ANALYSIS OF EX-VESSEL STEAM EXPLOSIONS
FOR THE COMBUSTION ENGINEERING SYSTEM 80+
USING THE GT3FTM COMPUTER CODE

(Supplemental Report)

RESPONSE TO COMMENTS

Figure II.7 (Corresponding to Figure 2.10 in [1])
Central Instrument Tube Failure-Propagation

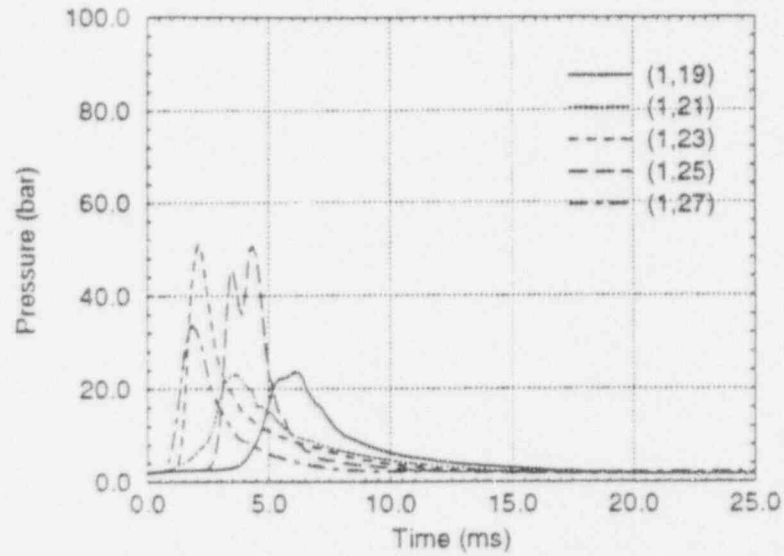
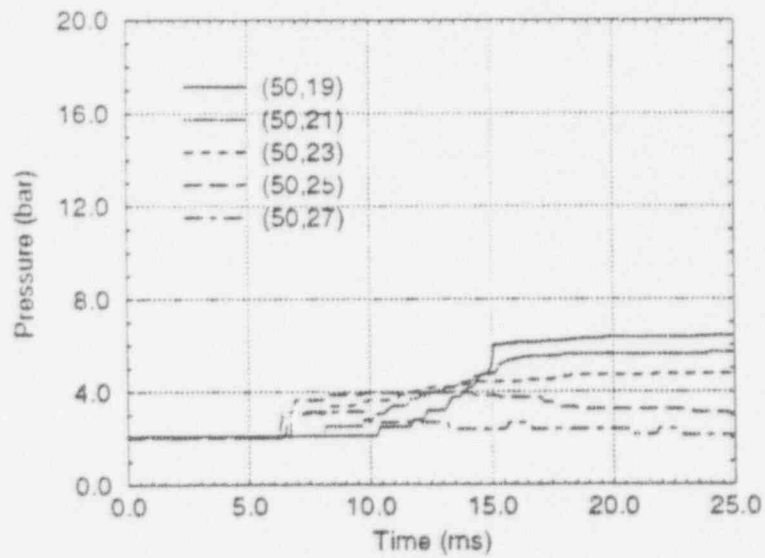
Comment II.7

The new calculation results representing an initially subcooled water pool, depicted in Figure II.7 of the enclosed supplement report [2] give somewhat different numbers. The maximum depicted pressure at corbel support (node (50,19) in Figure II.7 b) is approximately 6.5 bars, compared with a maximum pressure of approximately 26 bars at the same elevation on the centerline (node (1,19) in Figure II.7a).

One should remember that the explosion zone is approximately a cylinder. Follow-

ing triggering, the code predicts multiple explosions at various heights. The apparent flat pressure histories at the corbel support surface are due to the arrival of pressure waves, resulting from these multiple explosions, at different times. The arriving pressure waves tend to overlap and hence it is not a straightforward matter to attenuate the calculated pressure histories from 1-D calculations to the outer boundaries of the calculated domain. We agree that the calculated impulse on the corbel support would be somewhat higher, had the calculation been performed for a longer period. However, as can be seen in Figure II.7 and III.8, the calculated impulse values along the molten fuel jet centerline are reasonable since, within 20 ms after triggering (which represents the integration time period for calculated impulses), the pressures have decreased to the base pressure value.

Figure II.8
Central Instrument Tube Failure

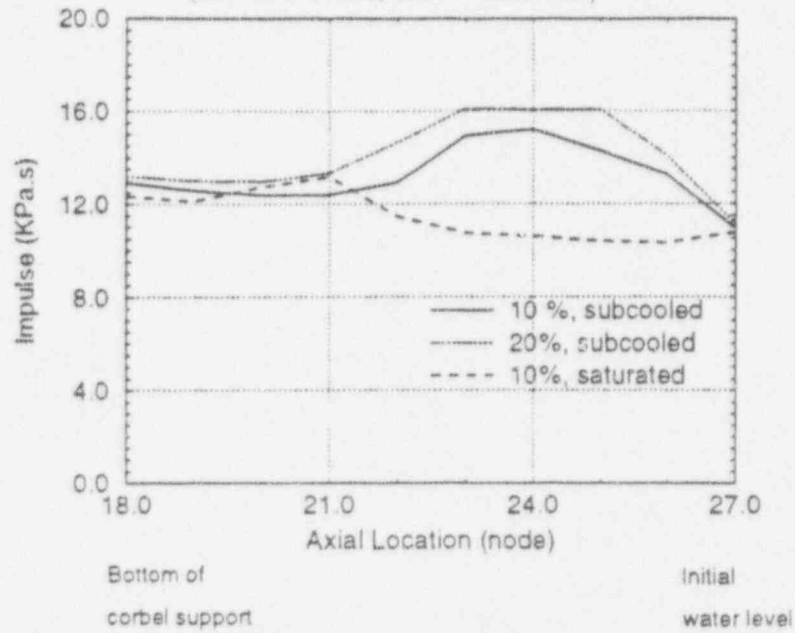
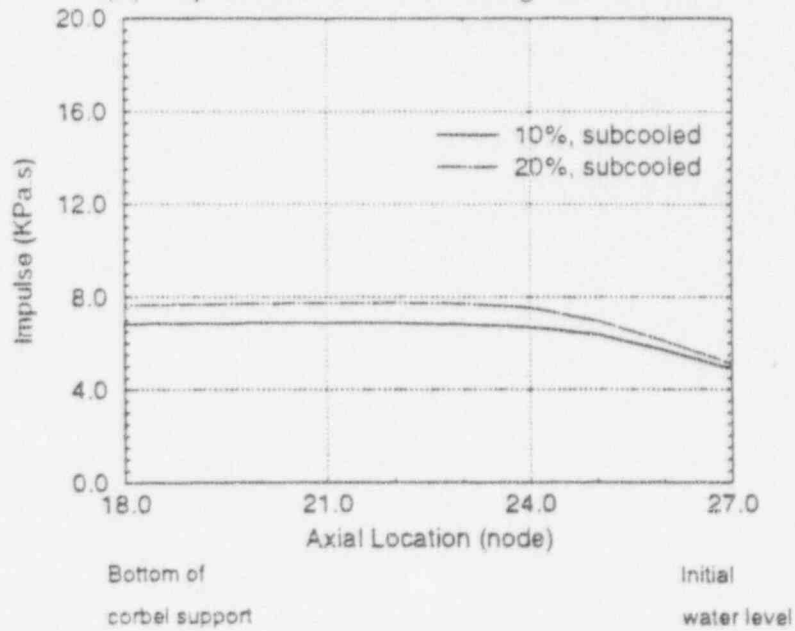
Comment II.5

In the repeated calculations for central instrument tube and outer instrument tube failure scenarios discussed in the enclosed supplement report [2] (see also response to General Comment I) we have included the calculated pressure impulse distributions for both the molten fuel jet centerline and the corbel support surface. The calculated results for both the initially saturated and subcooled water pool cases are once again lower than those predicted by the TEXAS code.

Figure II.9
Central Instrument Tube Failure-Propagation
Pressure (bar)
($\Delta r = 3.0$ cm, $\Delta z = 20.0$ cm, 20% Triggering)

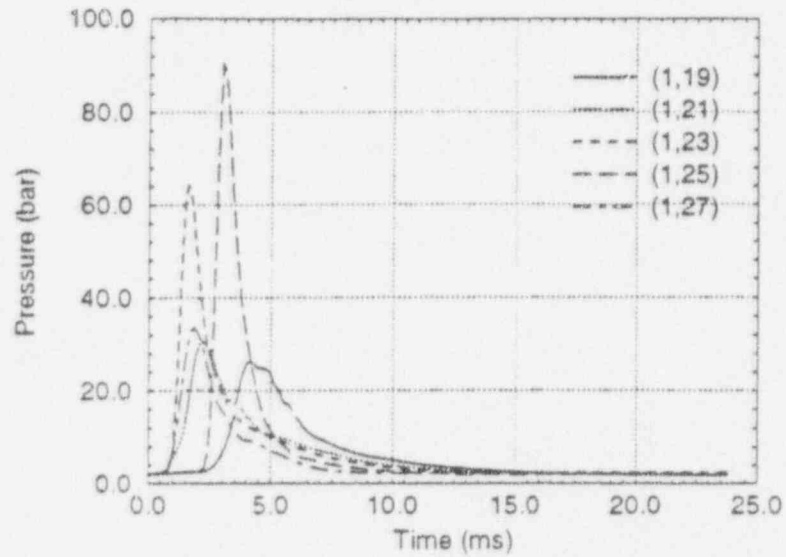
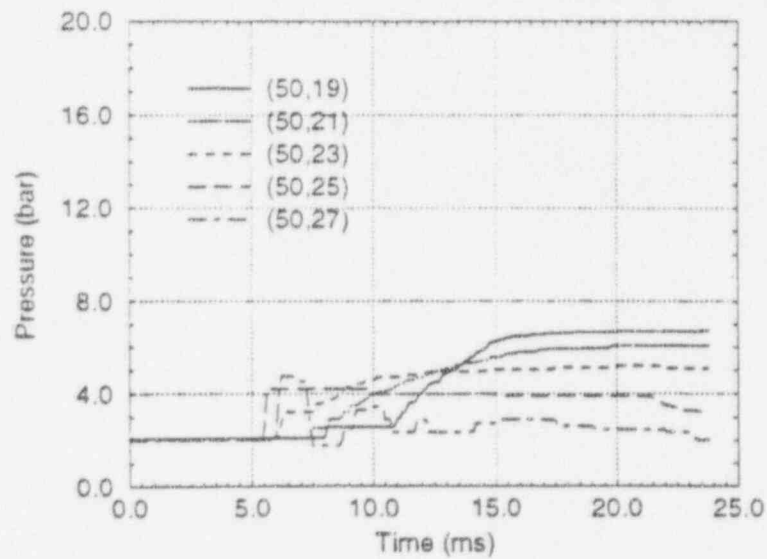
Comment II.4

Regarding the effect of the triggering strength on the predicted results, please see Section II.3 of the enclosed supplement report [2], where we have compared results obtained assuming 10% and 20% fuel fragmentation in one time step ($2 \mu s$), in the triggered node. These results, as noted, indicate that the pressure histories far away from the triggering location are relatively insensitive to the triggering strength. They also indicate that the impulse distribution in the explosion zone is only slightly affected.

Figure III.4: Outer Instrument Tube Failure
(Shaded area represents computational domain for propagation calculation)

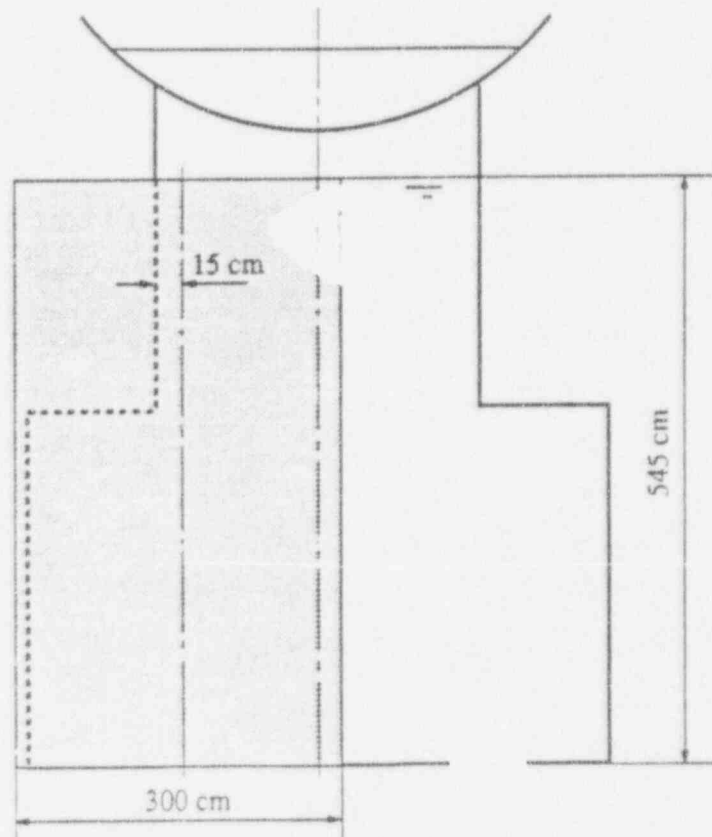
Comment III.2

We agree with the reviewers' comment regarding the conservative nature of pressure histories predicted by using a 30 cm-diameter cylindrical computational zone.

In the enclosed supplement report [2] we have repeated the simulation of outer instrument rupture scenario where we have used a computational domain 300 cm in diameter (Figure III.4 in the supplement report), as suggested by the reviewers.

The computational domain is entirely fluid, however, and does not include any flow obstruction. In these calculations, furthermore, the initial pool temperature was assumed to be 353 K, and triggering was simulated 4.5 m above the pool bottom. The predicted pressure histories for the molten fuel jet centerline and the radial nodes representing the physical location of the corbel support surface are shown in Figures III.8a and III.8b of the supplement report [2]. Comparing these figures with the results representing the central tube failure case (Figures II.7 a and II.7 b in the supplement report [2]), it can be noted that the predicted peak pressures in the two cases are comparable, and the differences can be attributed at least partially to the differences between the two systems at the end of premixing (the molten fuel jet has a slightly lower velocity in the outer instrument tube failure scenario). The predicted pressures along the corbel support surface, as expected, are significantly higher for the outer instrument tube failure, due to the proximity to the explosion zone.
